# Oil Sands Environmental Coalition

1 December 2016

**Re: The Syncrude Canada Ltd. Tailings Management Plan for the Aurora North Mine OSCA Application No. 1871794**

**Figure 1:** Expected Cumulative Tailings Under the TMF<sup>4</sup>

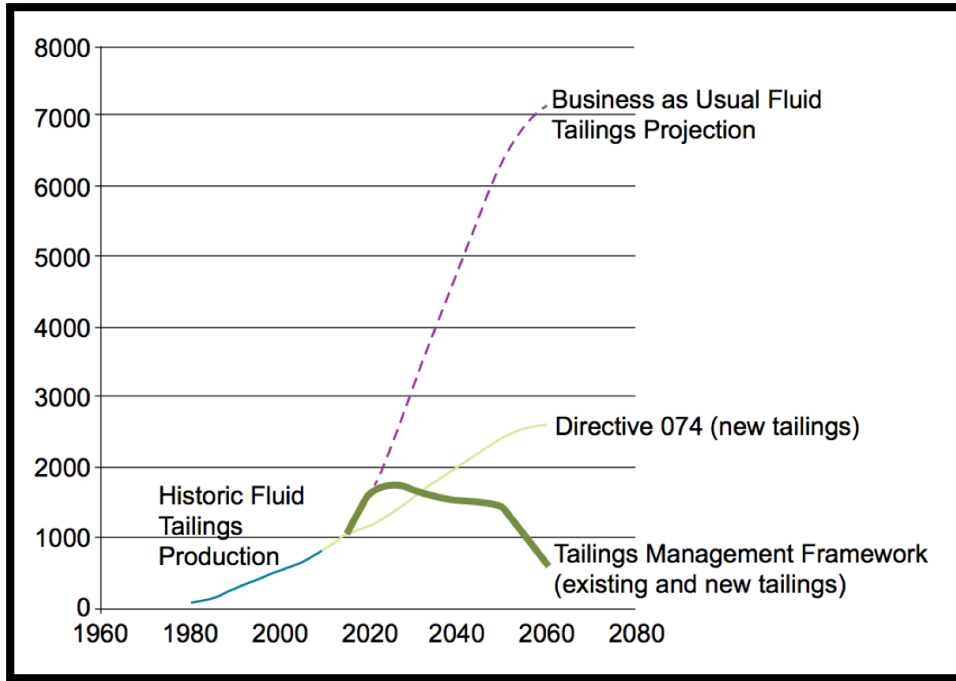
The TMF graphically outlines the expected cumulative trajectory of all fluid tailings on the landscape including a peak date for tailings accumulation, a rate of decline, and the point at which tailings cumulative tailings volumes will actually decline (**Figure 1**). OSEC has amalgamated the projected tailings volumes from all Directive 085 applications submitted to date, and compared it with the aforementioned TMF trajectory (**Figure 2**). This analysis has demonstrated a general trend wherein cumulative tailings volumes are peaking roughly ten years later than the TMF anticipated.

OSEC and the AER's ability to determine the adequacy of Syncrude's plans are correspondingly dependent on an assessment that the sum of the approved tailings plans are consistent with the TMF's objectives. As such, it is essential for regulators and stakeholders to compare all tailings plans in conjunction to ensure responsible regulatory decisions are made. We thereby strongly recommend that no applications be approved until all proponent plans have been reviewed.
